Serial No. 10/620,590

Docket No. P-0520

Reply to Office Action of June 15, 2004

REMARKS/ARGUMENTS

FIG. 6

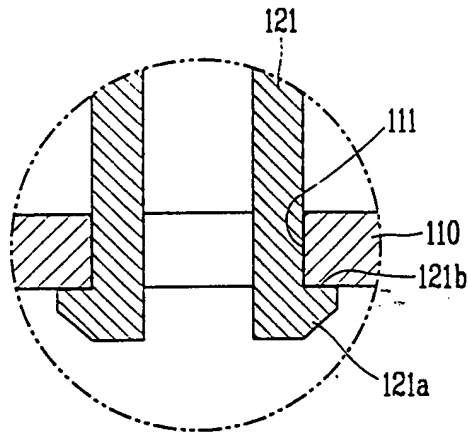
In Figure 6, one of the two reference numerals 151 has been deleted to accurately reflect the position of the hole 151 formed in the contactor 150.
